# City of Portland Design Commission

## Design Advice Request

### SUMMARY MEMO

**Date:** April 4, 2025  
**To:** Kyle Andersen, GBD Architects  
**From:** Benjamin Nielsen, Design & Historic Review Team  
503-865-6519, benjamin.nielsen@portlandoregon.gov  
**Re:** EA 25-013501 DA – Sellwood Bluff Multi-Dwelling Residential  
Design Advice Request Commission Summary Memo – March 20, 2025

SITE PLAN - OUTDOOR AREA + ZONING DIAGRAM AT ROOF

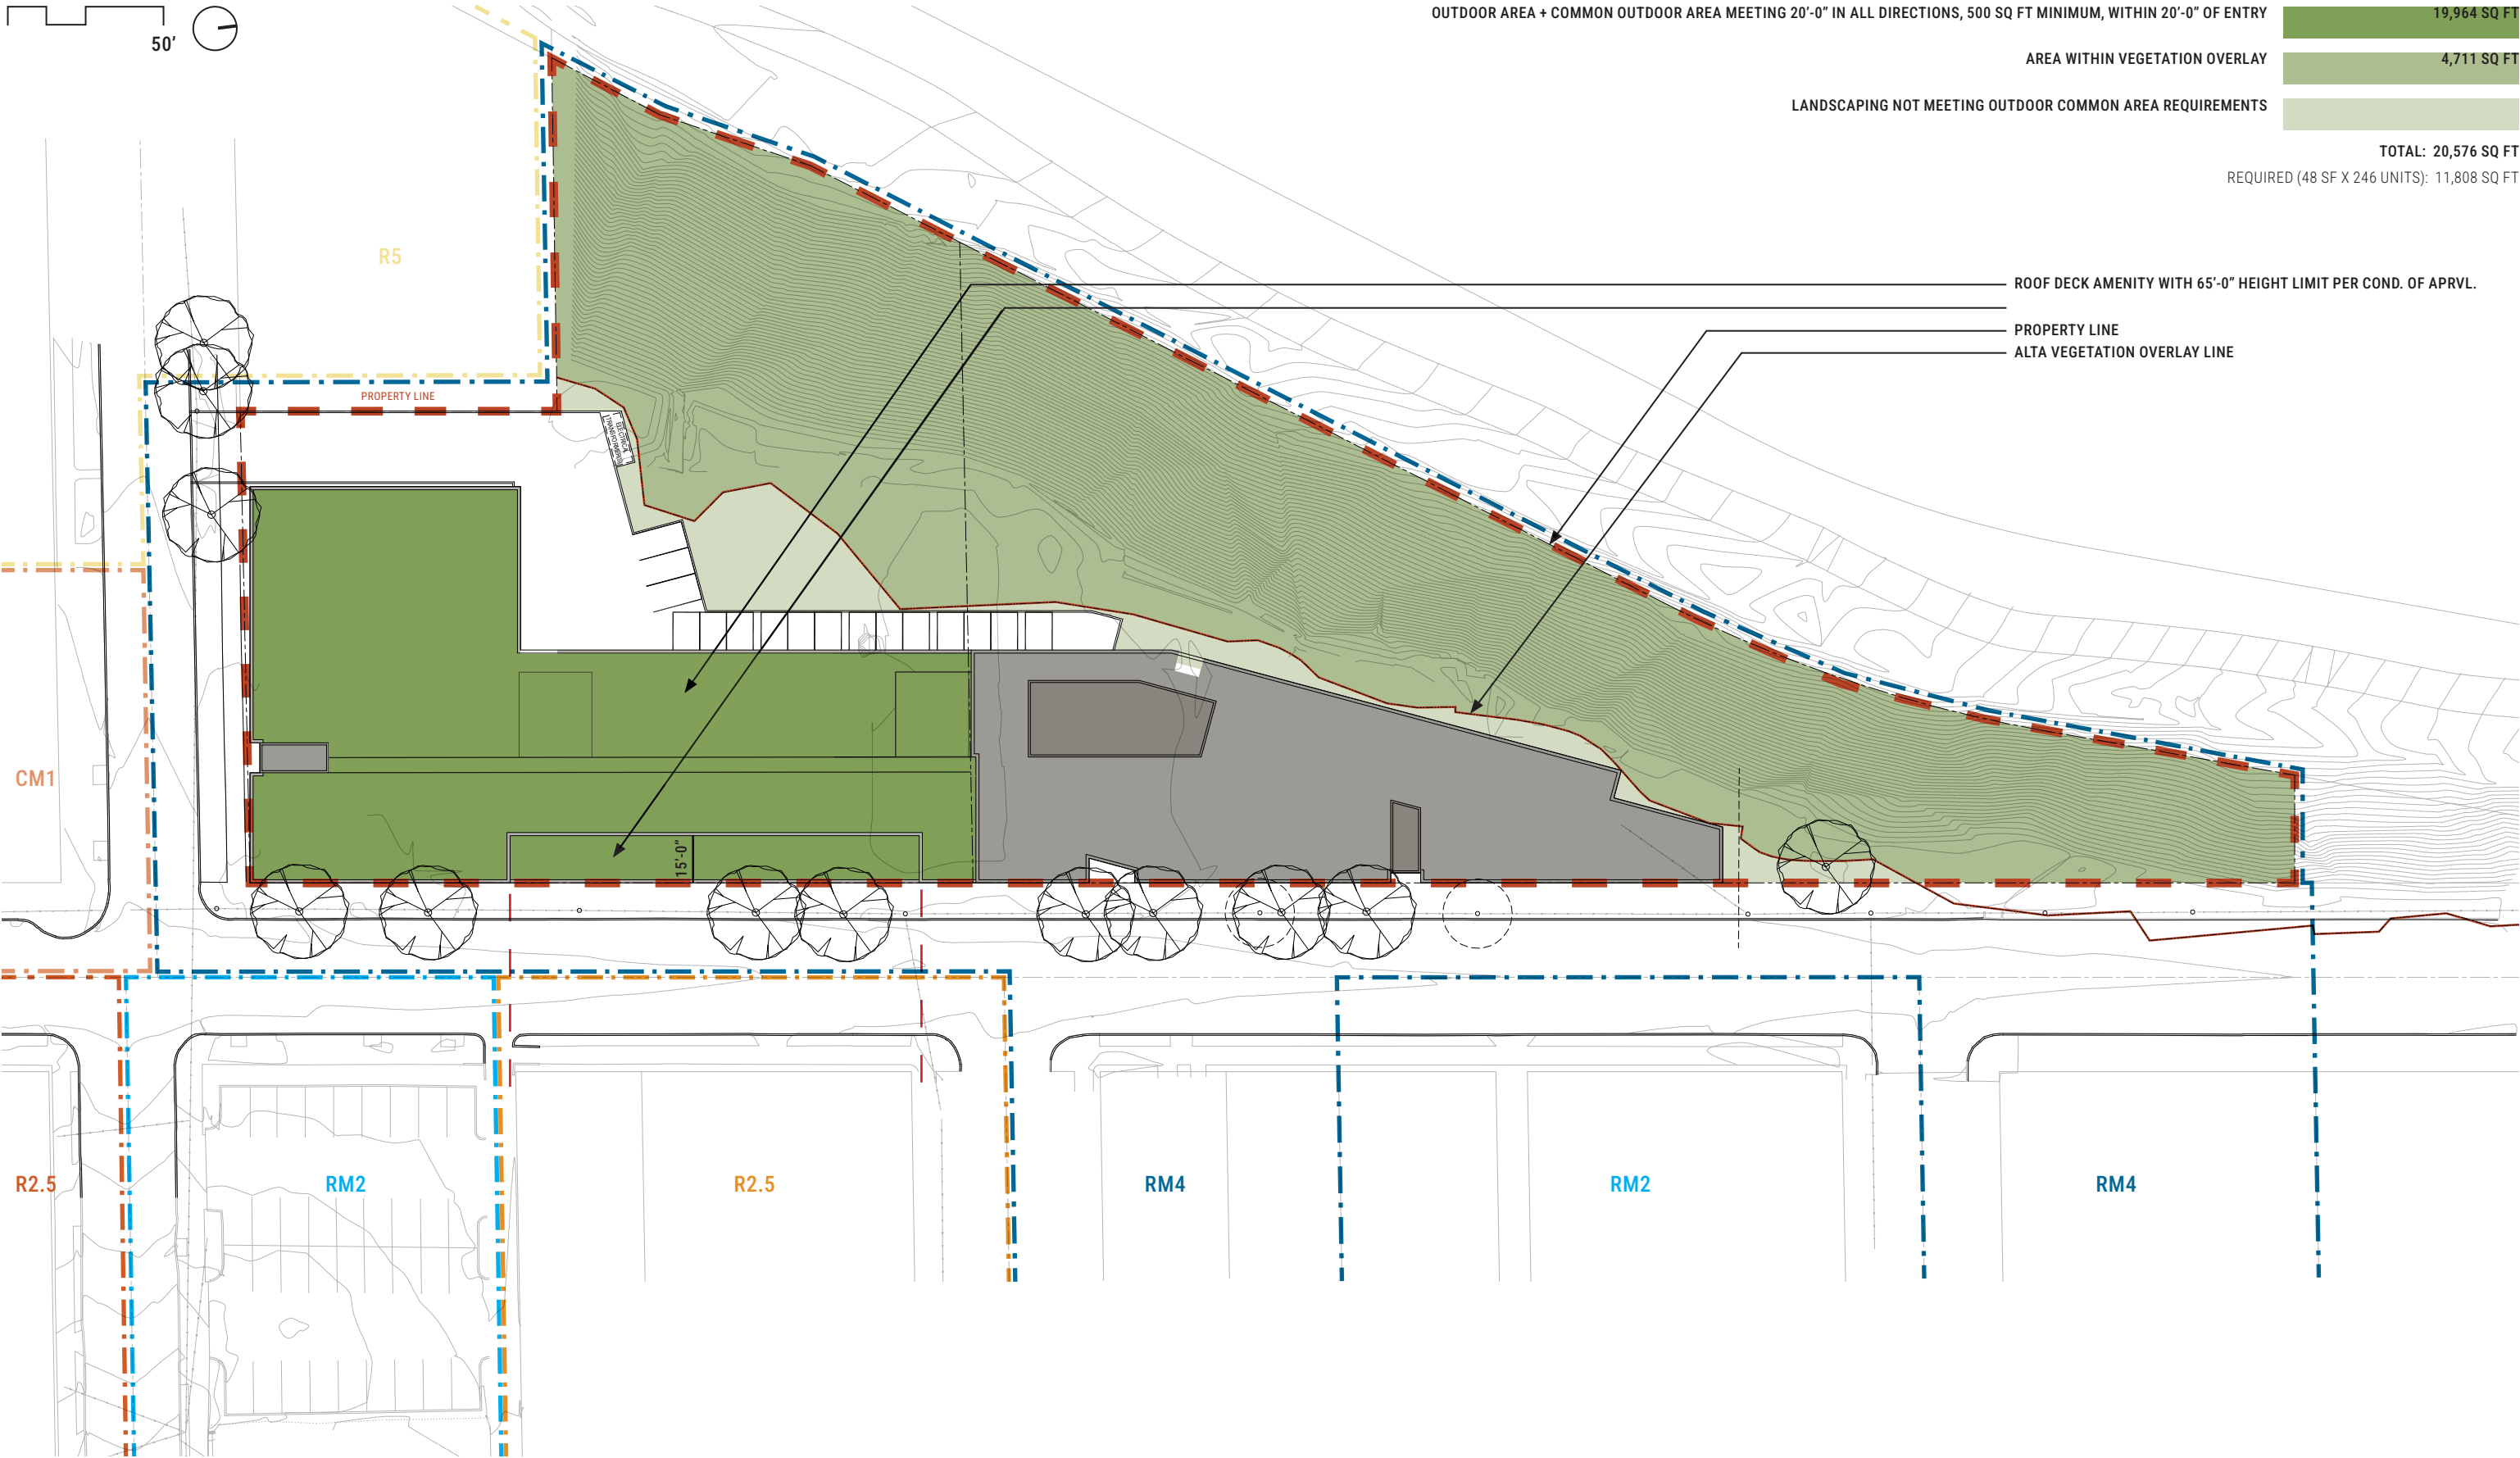
- Comments related to Quality & Permanence generally worked hand-in-hand with comments related to the overall contextual response. Commissioners did not cite specific issues with proposed materials, and they agreed that the overall concept, material palette and expression of materials, articulation, and related details should be simplified to create a more cohesive design. This simplification should help the project’s pro forma.
- Commissioners appreciated the use of the green roof as both a space for stormwater management and outdoor common area.

- Commissioners expressed no concern regarding a potential Modification to the pedestrian standard requiring a connection from a main entry to the public trail below the bluff.
- The Commission encouraged the development team to find additional areas on the site and/or rooftop to meet the required common area standard, before requesting a Modification.

BUILDING SECTIONS

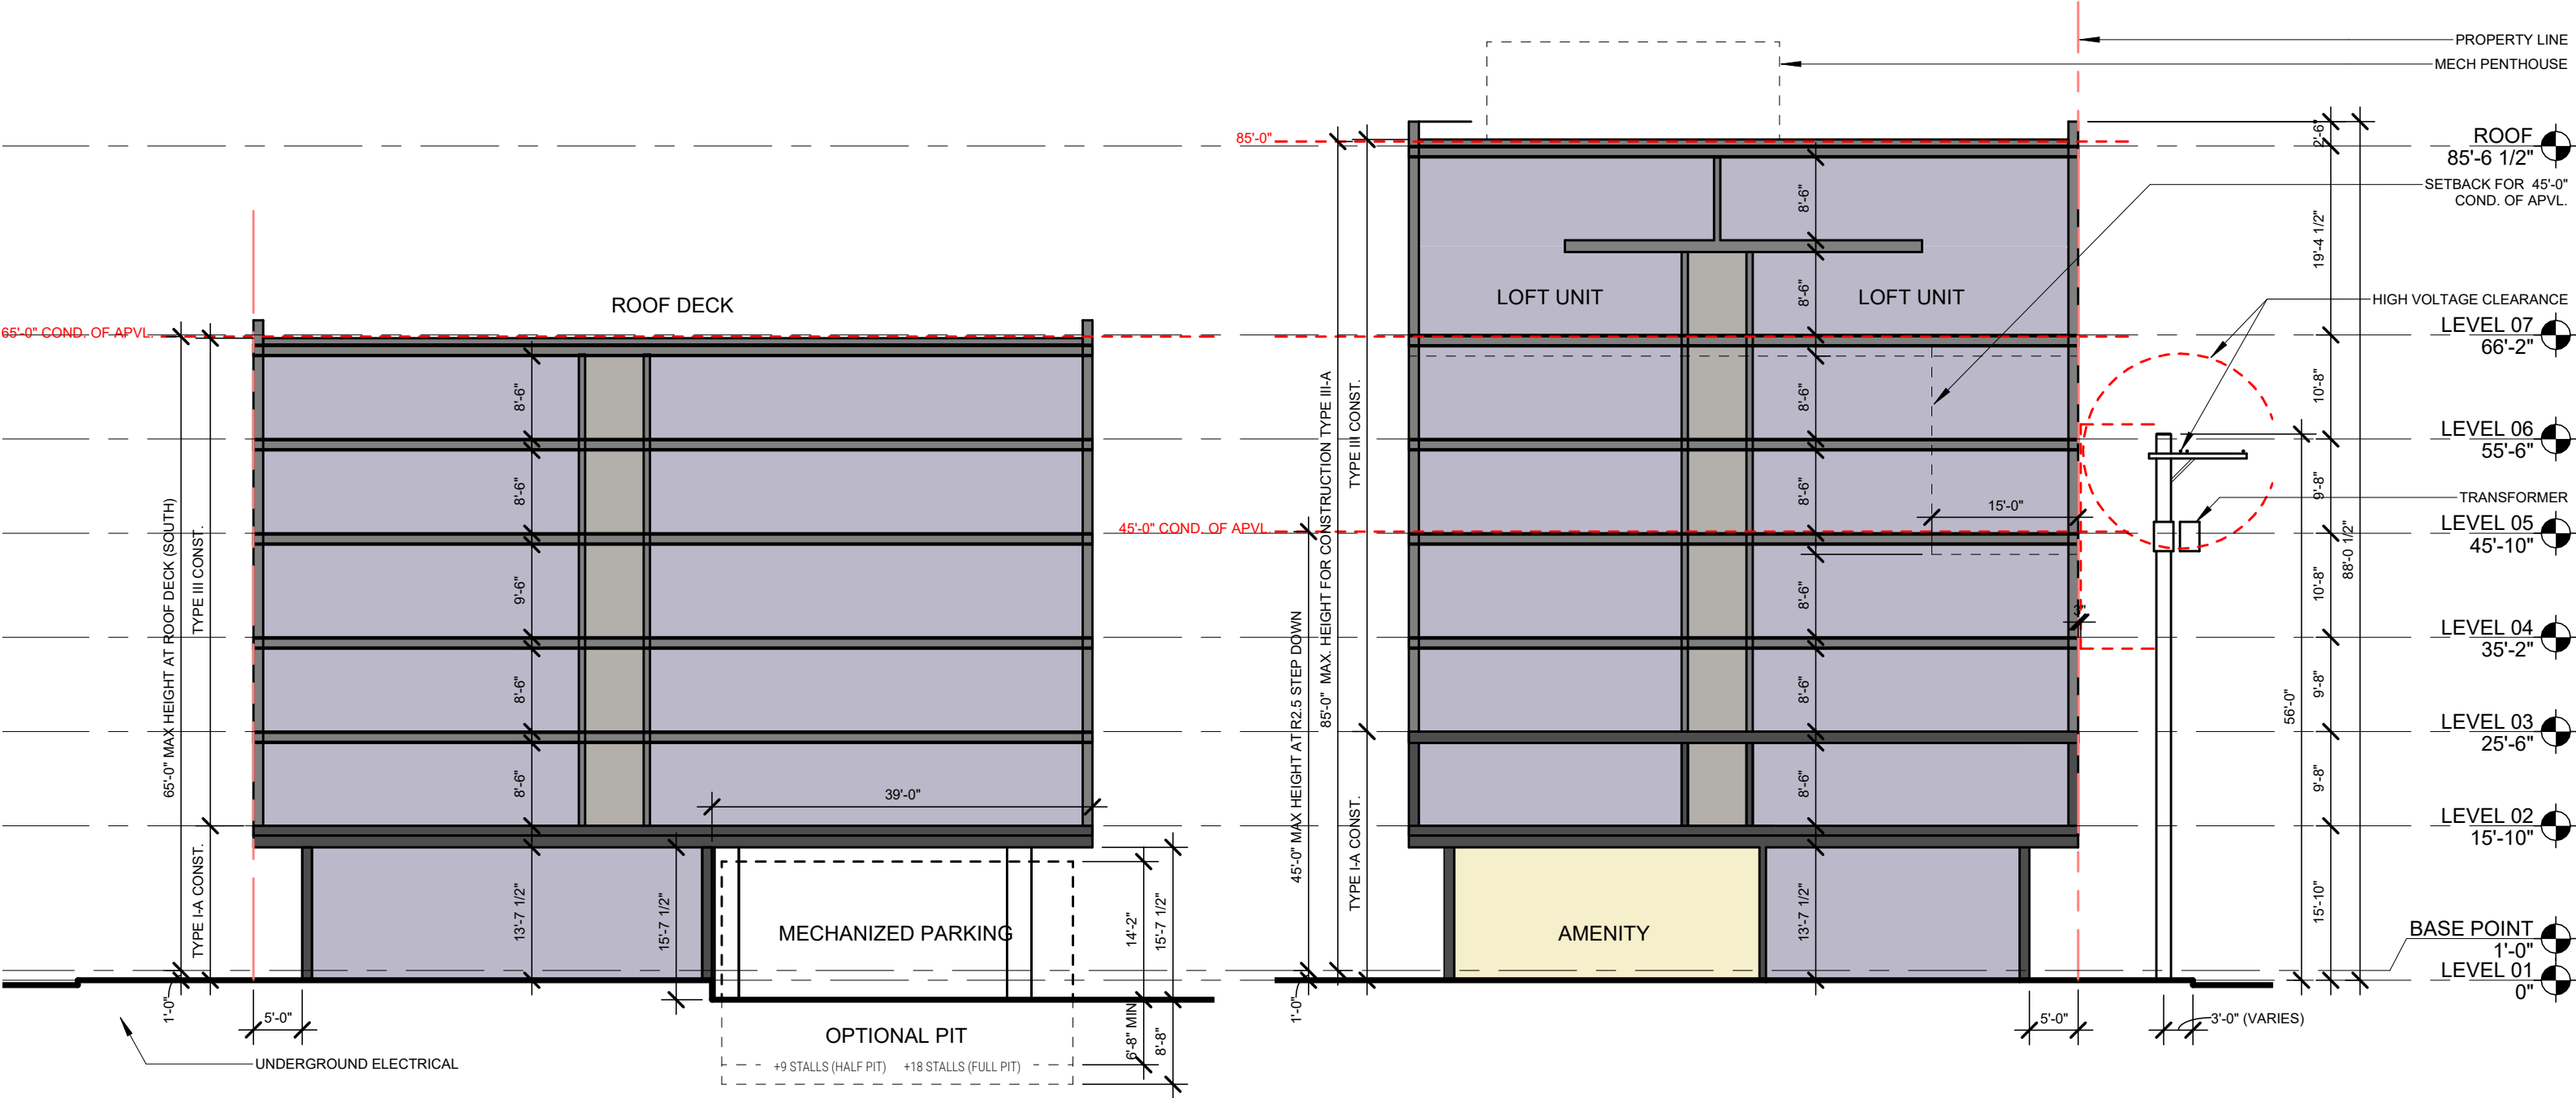
- One commissioner asked that, when drawing cross sections that the sections extend through the buildings across the street and down the embankment to better address the context guidelines and *PCDG 04: Design the sidewalk level of buildings to be active and human-scaled*.

FRONT ENTRANCE - LOGGING RAFT

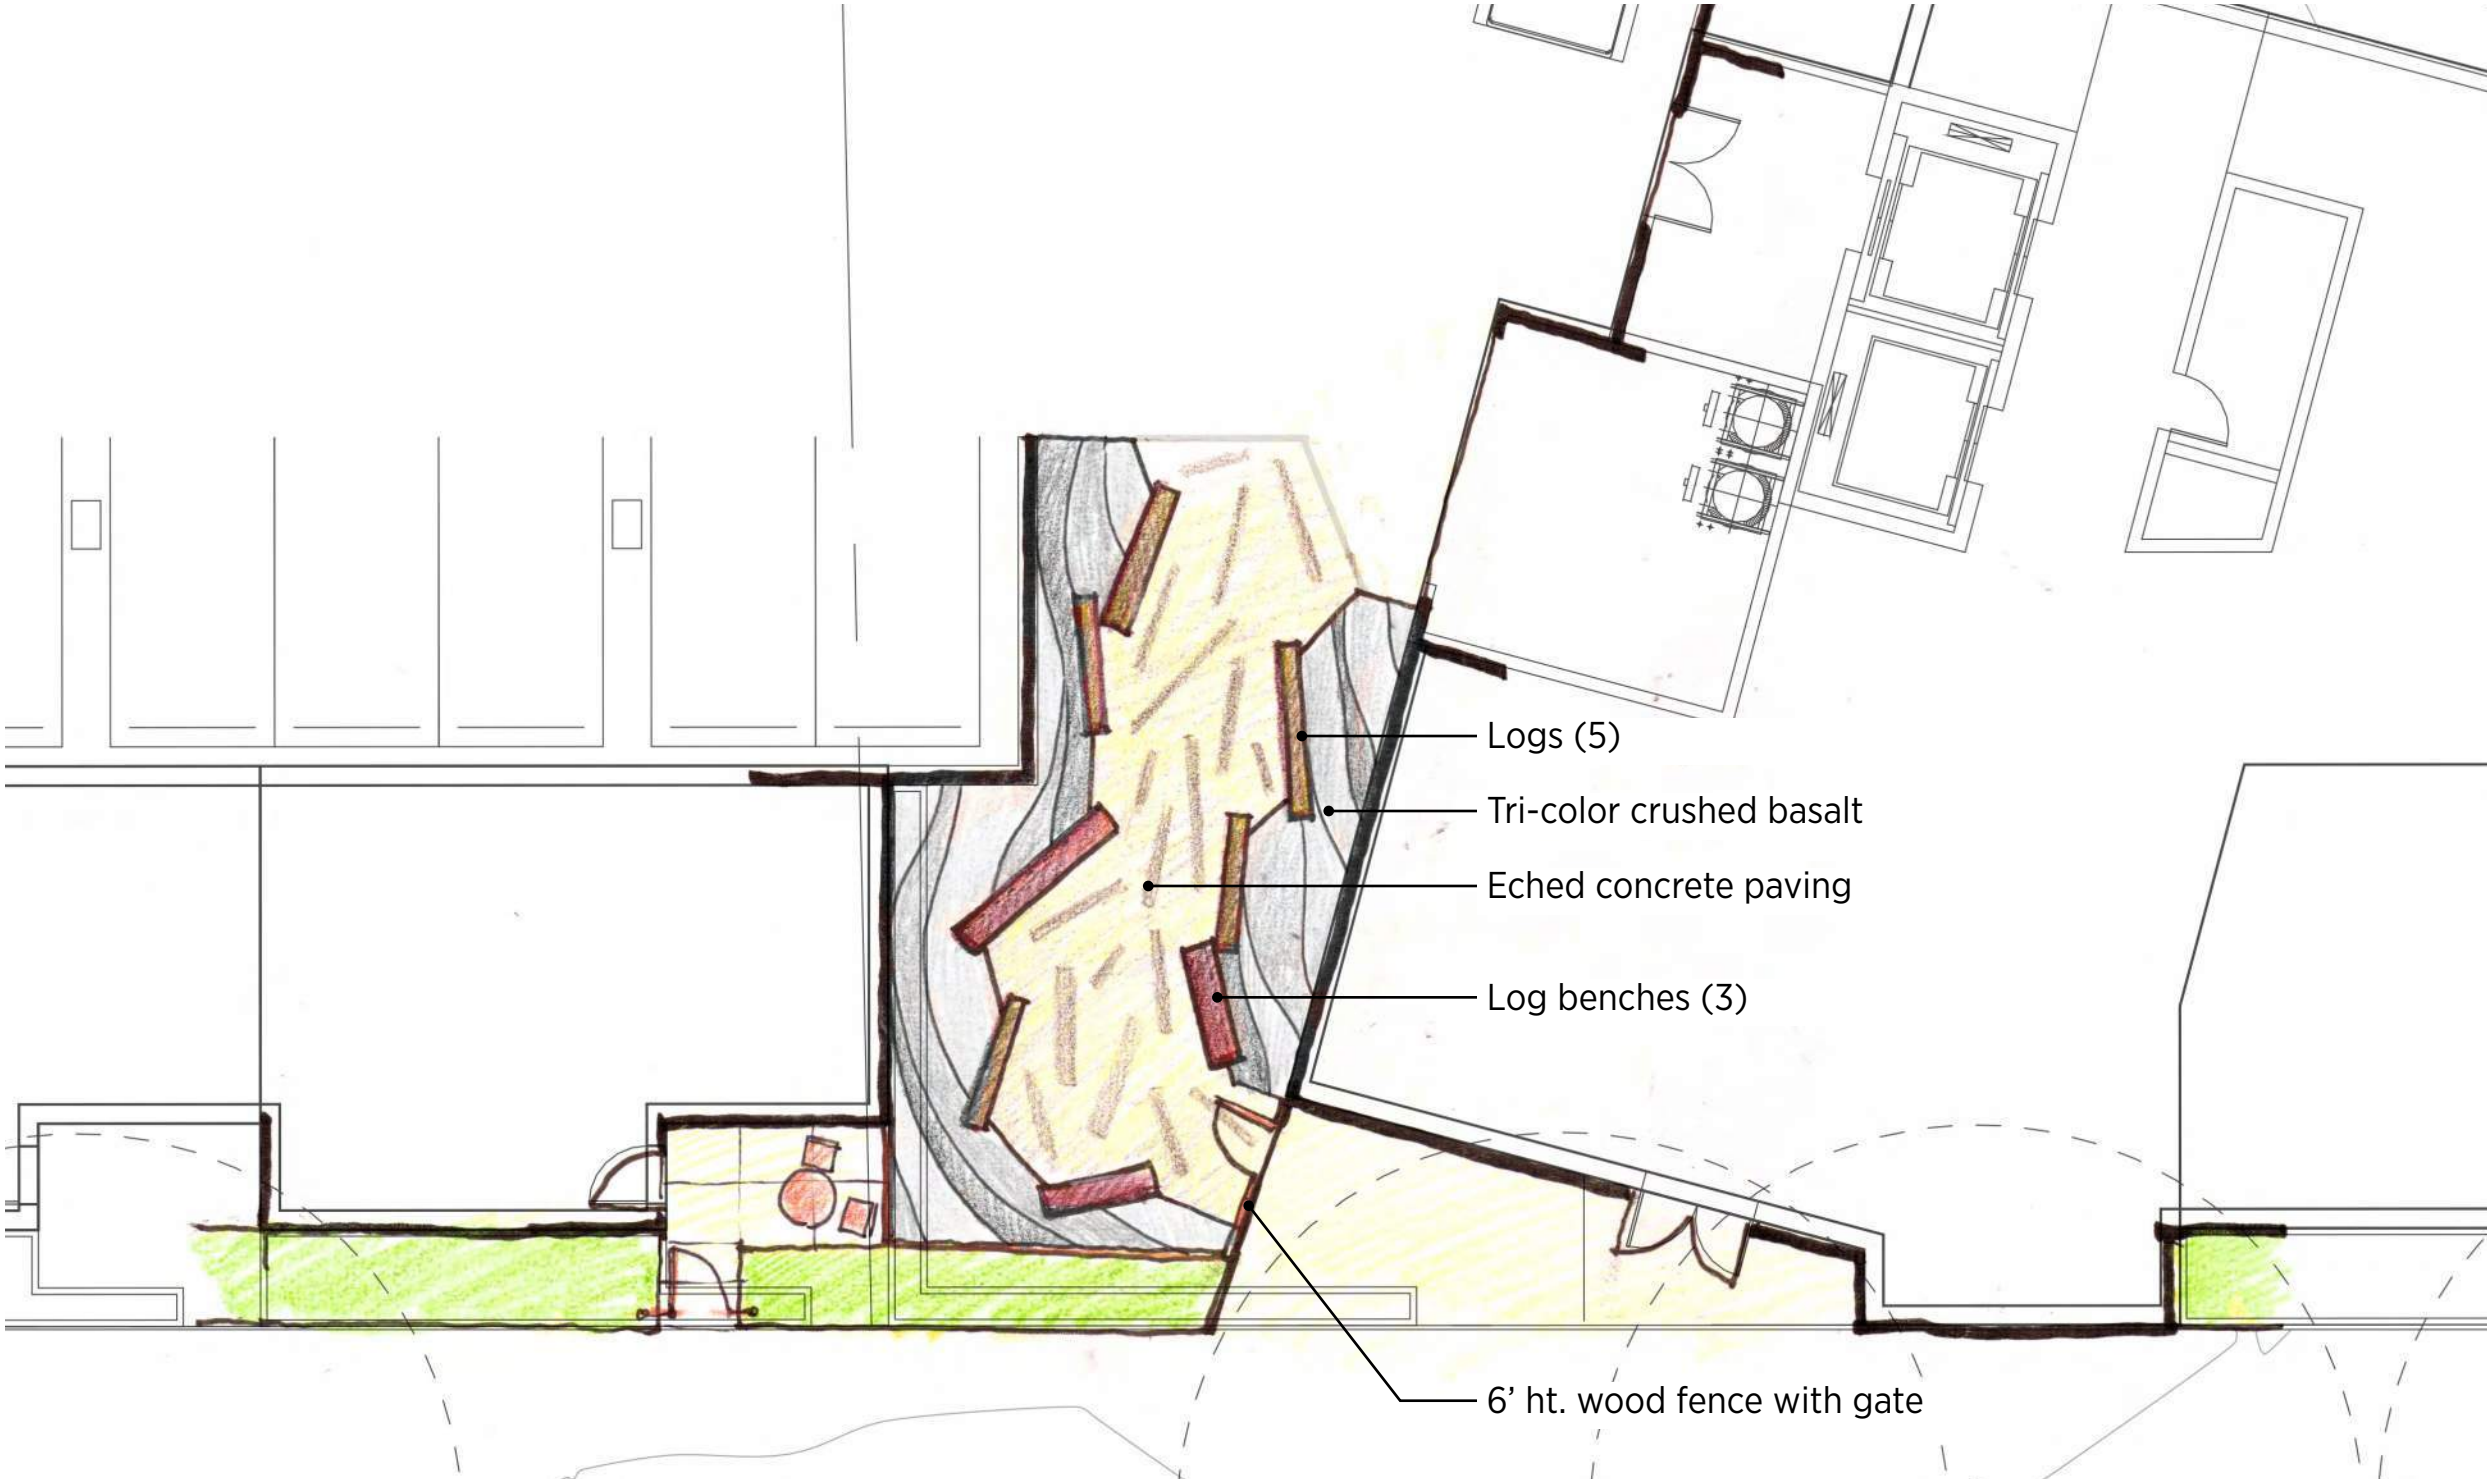
- Related to this, commissioners had a mixed response to the proposed “logging raft” space connecting from the lobby courtyard through the building to the parking lot. Commissioners appreciated that the outdoor space was located near the main entrance, but some questioned how comfortable of a space that would be when under full cover and opening directly into the parking garage. Additional study should be given to this space to ensure that it is comfortable and truly useful for tenants and their guests.
